ADDENDUM NO. 1
TO INVITATION TO BID FOR THE
HALE CREEK ENHANCEMENT PILOT PROJECT
Project No. 26164001 Contract No. C0667
Invitation No. VW0077

ADDENDUM NO. 2
TO INVITATION TO BID FOR THE
HALE CREEK ENHANCEMENT PILOT PROJECT
Project No. 26164001 Contract No. C0667
Invitation No. VW0077

ADDENDUM NO. 3
TO INVITATION TO BID FOR THE
HALE CREEK ENHANCEMENT PILOT PROJECT
Project No. 26164001 Contract No. C0667
Invitation No. VW0077

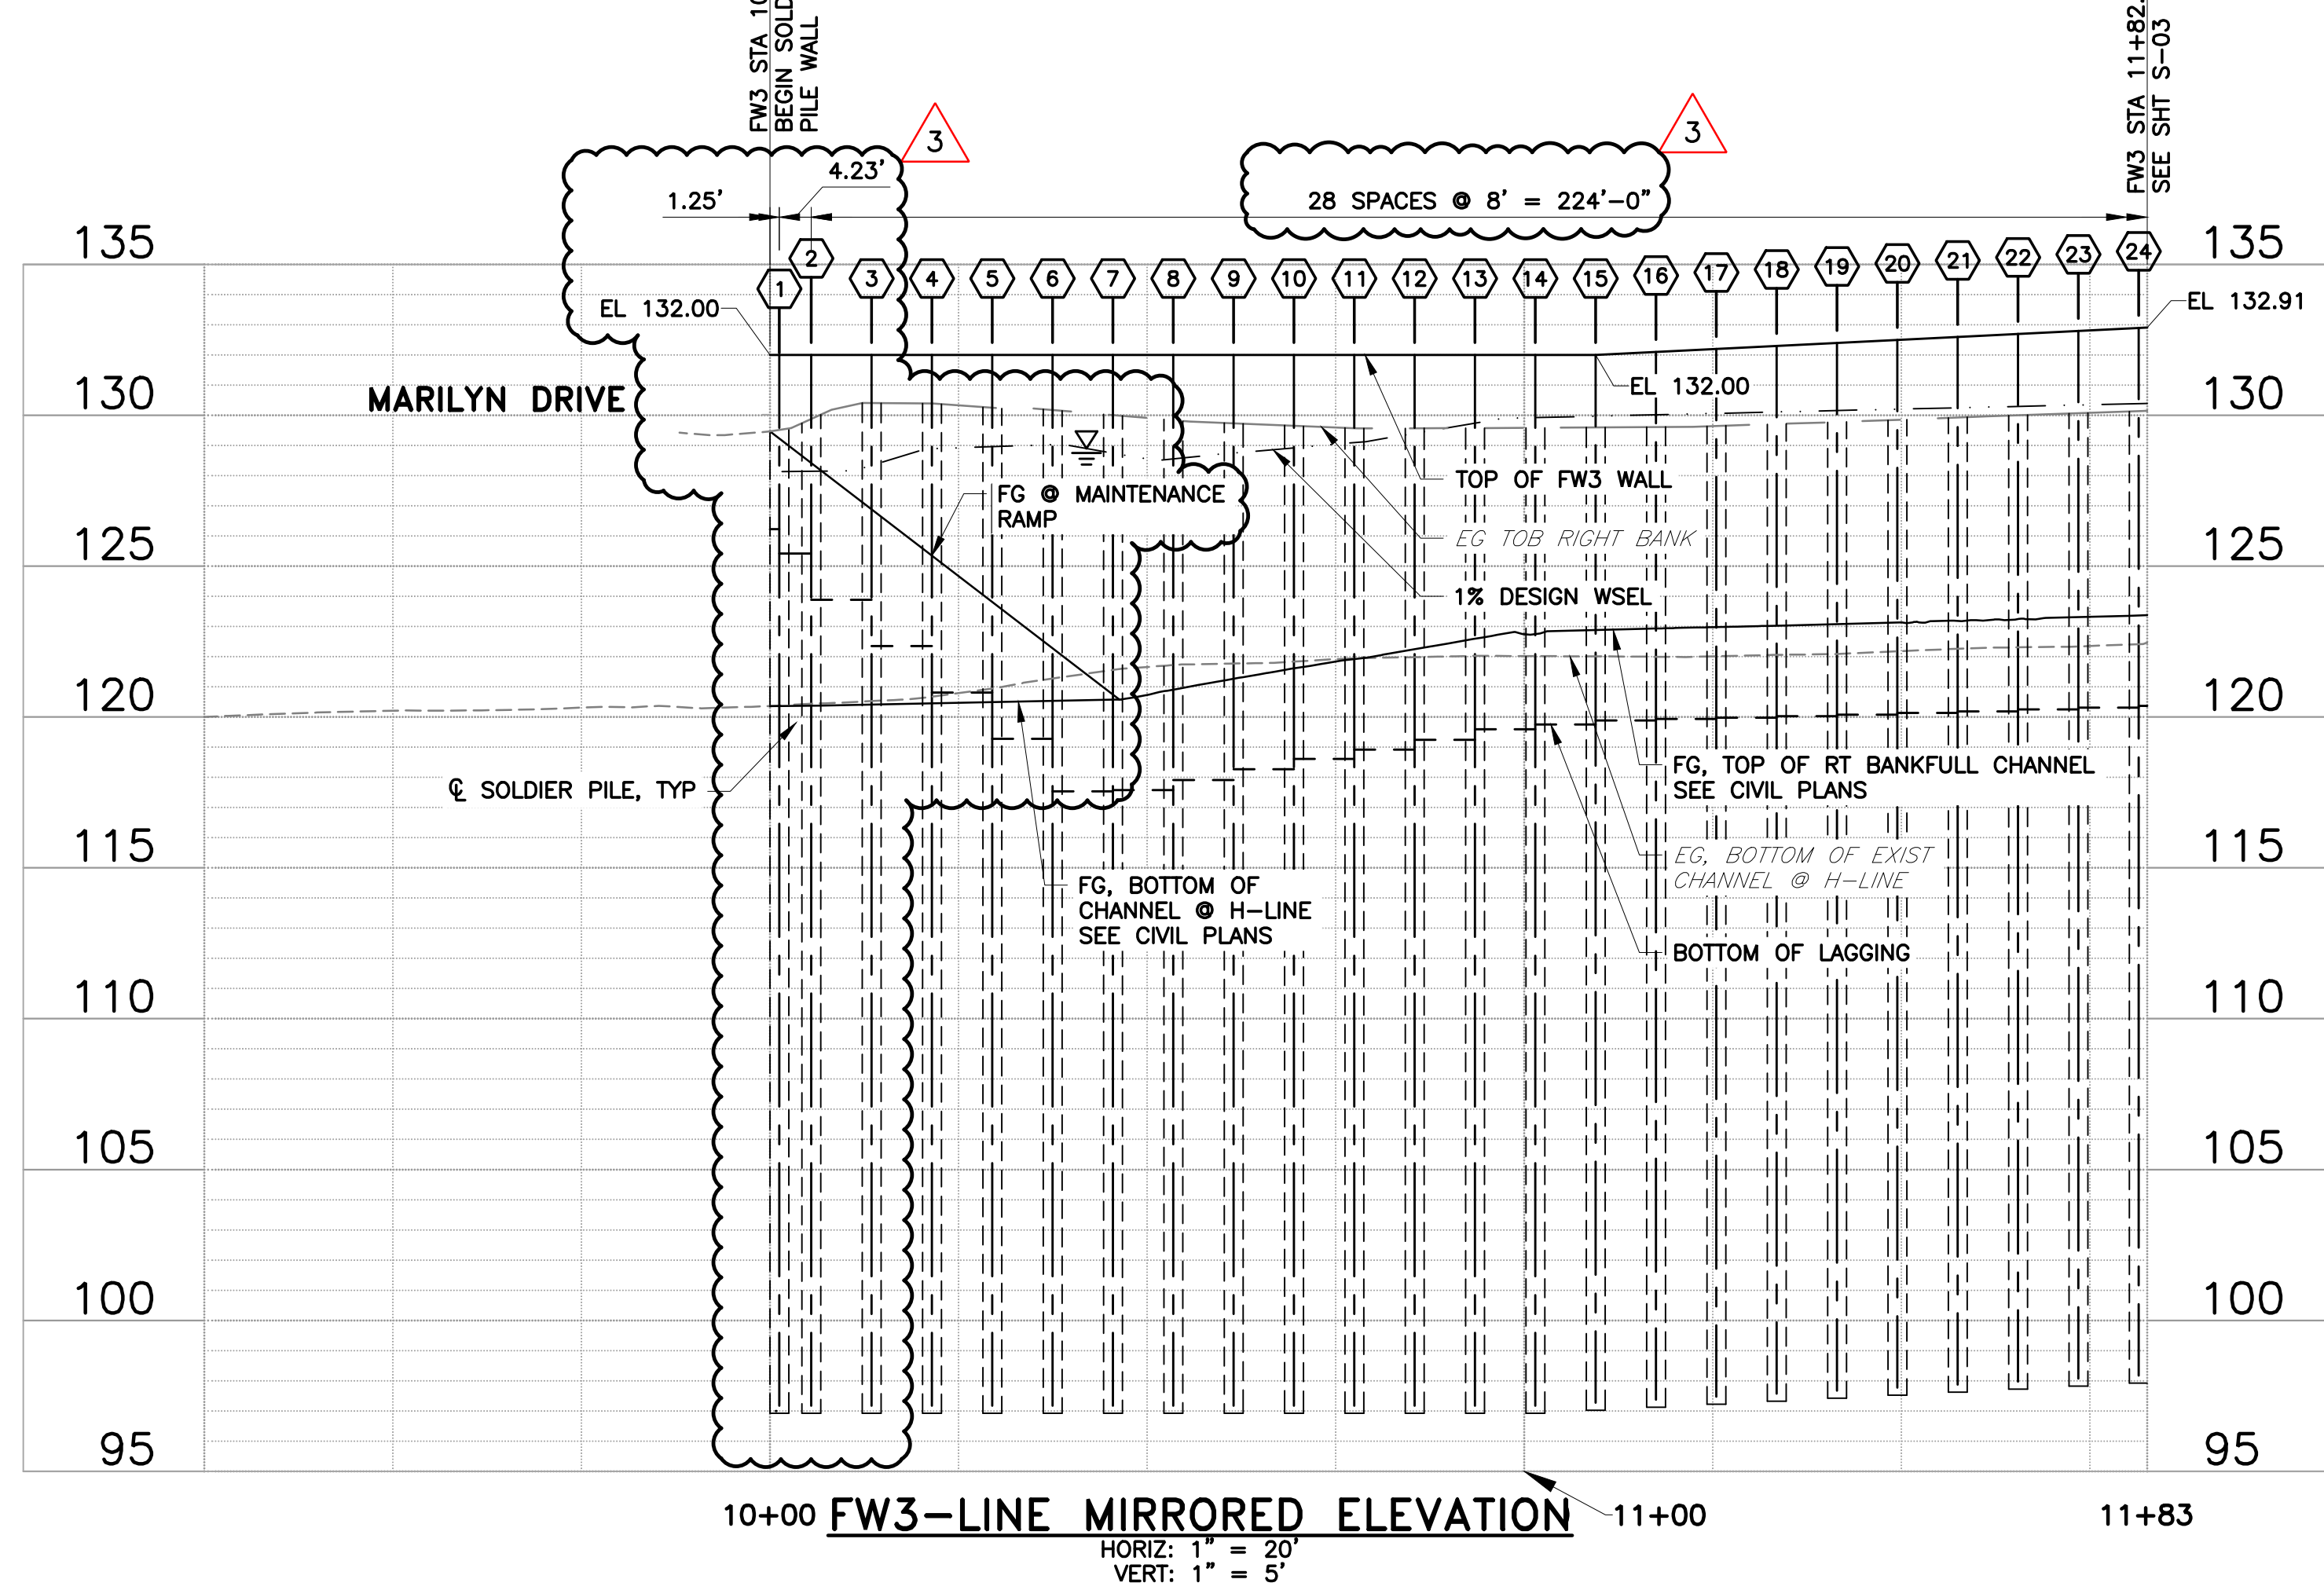
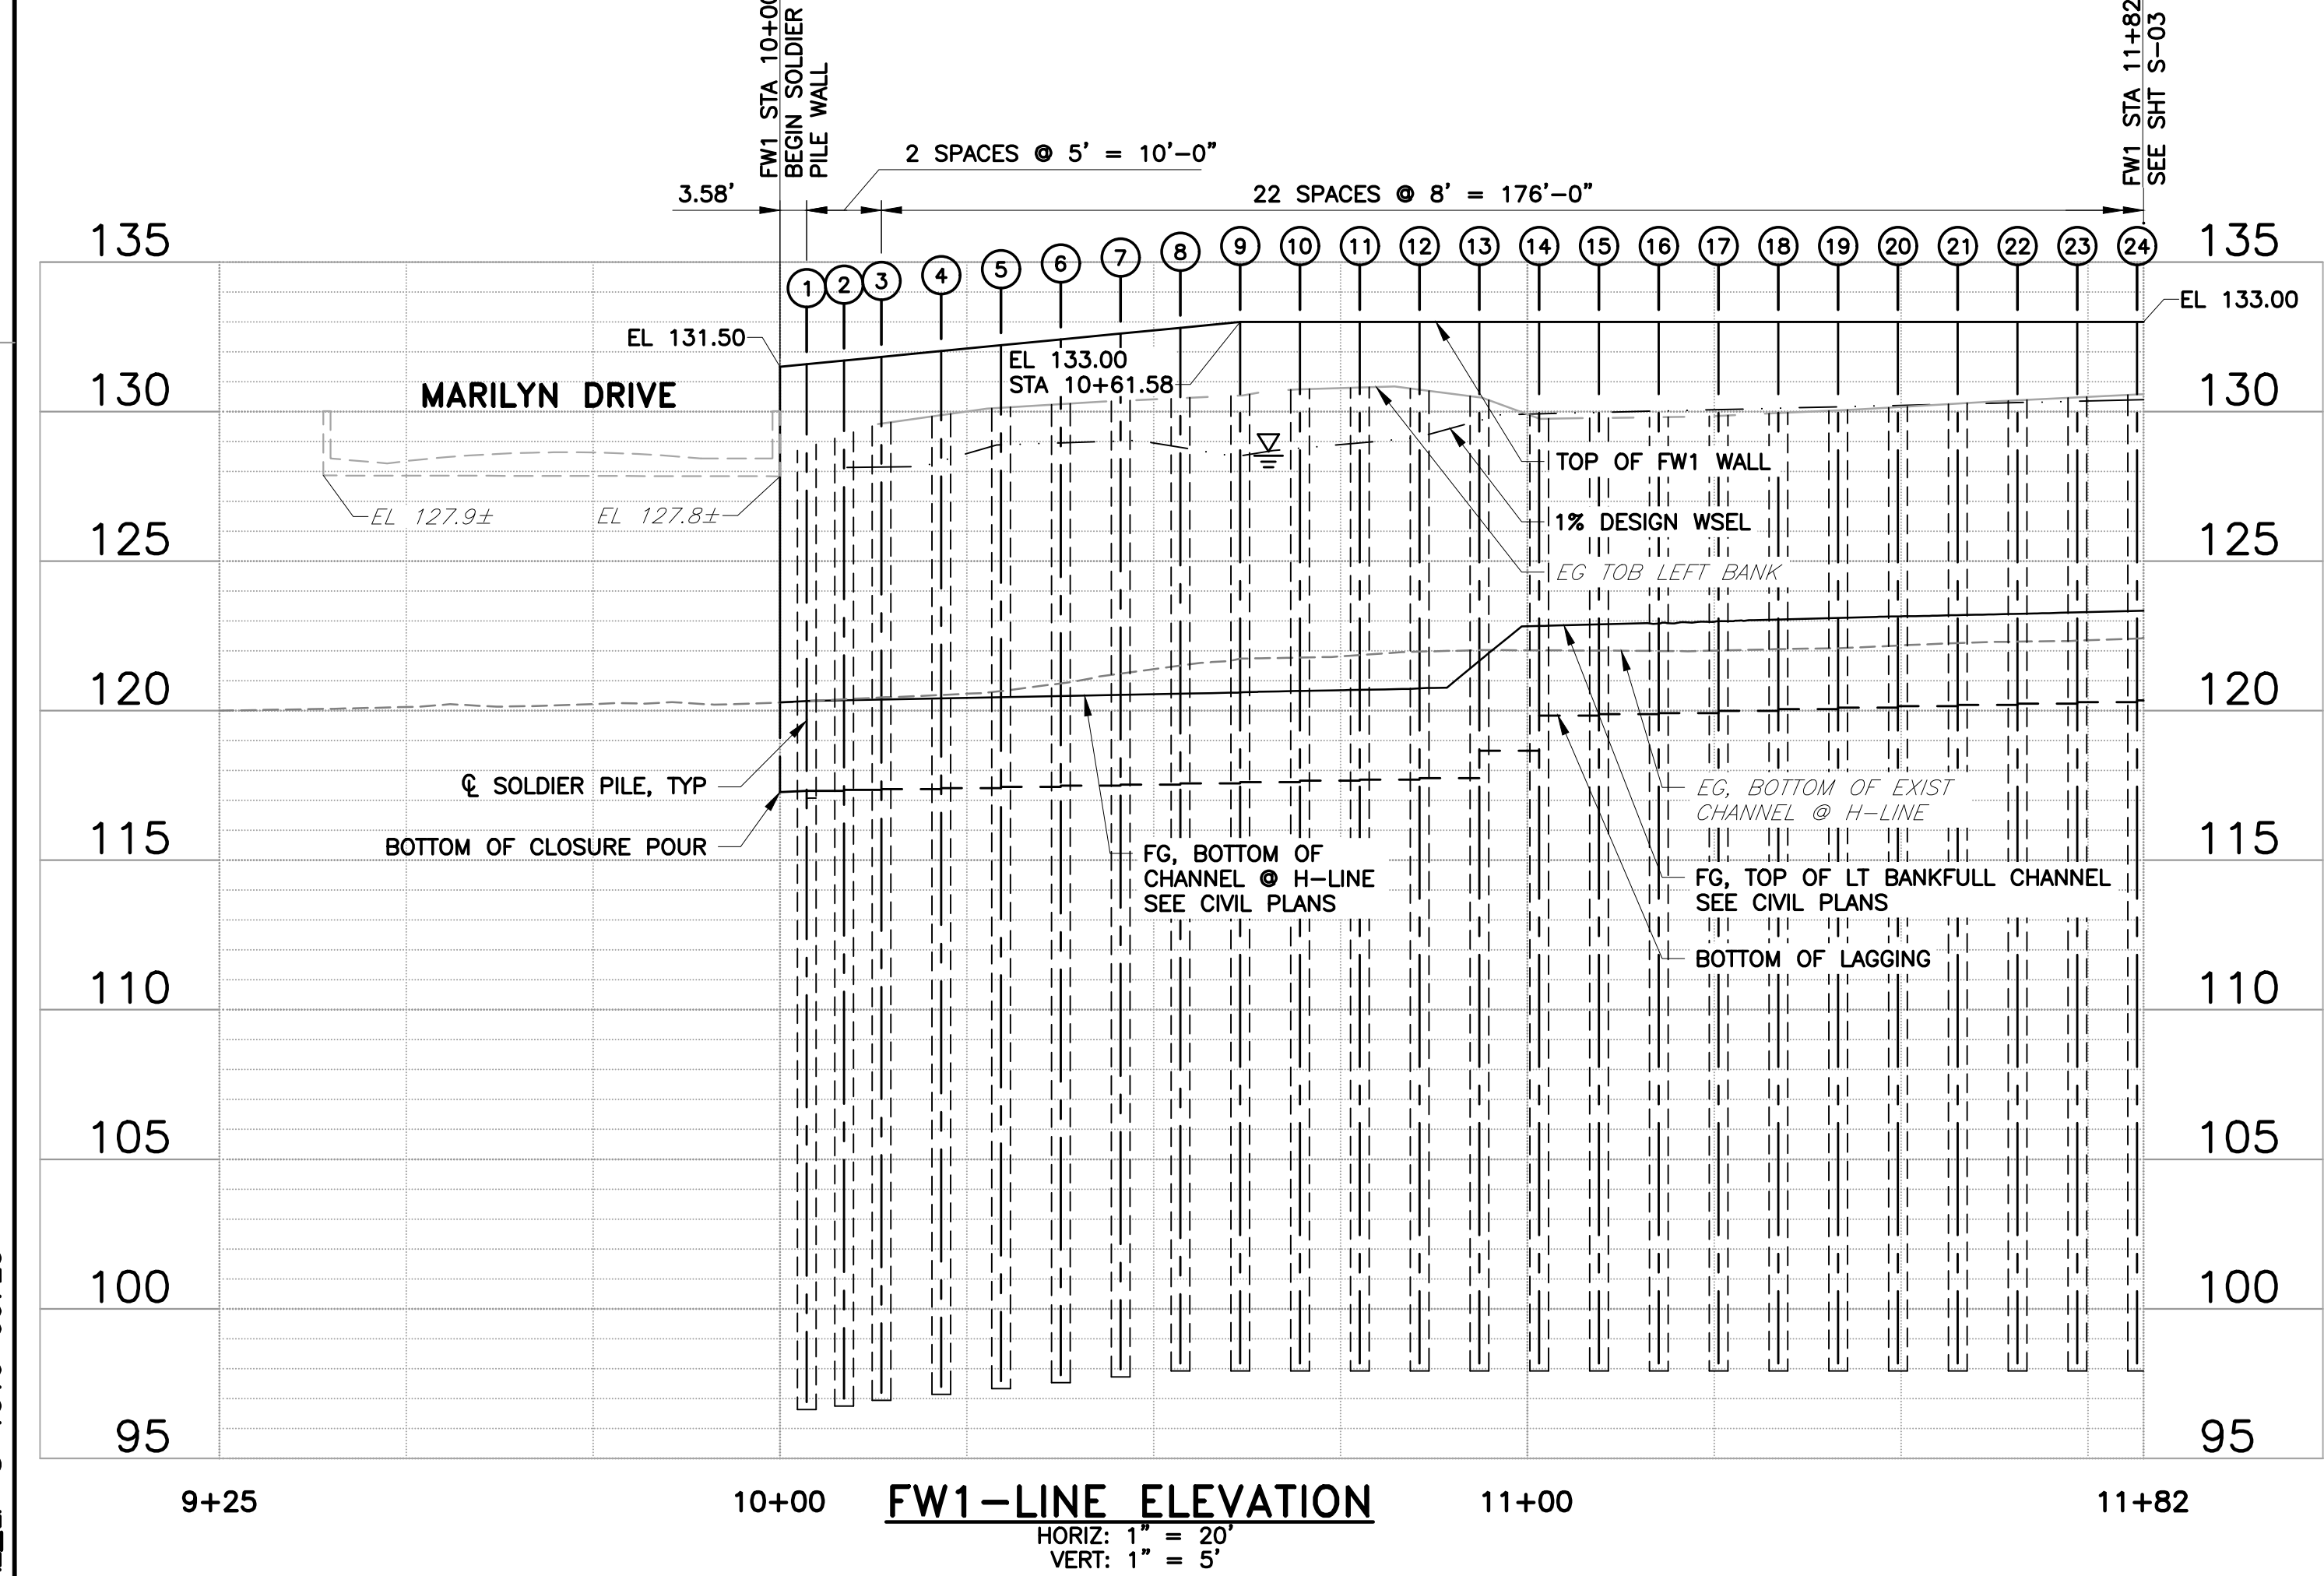
FW-1 wall has a closure pour and a reference to the closure pour detail has been added to Sheet Code S-02 (Sheet No. 30 of 58). FW-3 wall doesn't connect to the bridge structure and therefore doesn't require a closure pour. Sheet Code S-02 (Sheet No. 30

of 58) was revised to show no closure pour at FW-3 wall and lagging depth to 3 feet minimum below maintenance ramp final grade elevation. See Item No. 2 and Item No. 3 of this Addendum No. 3.
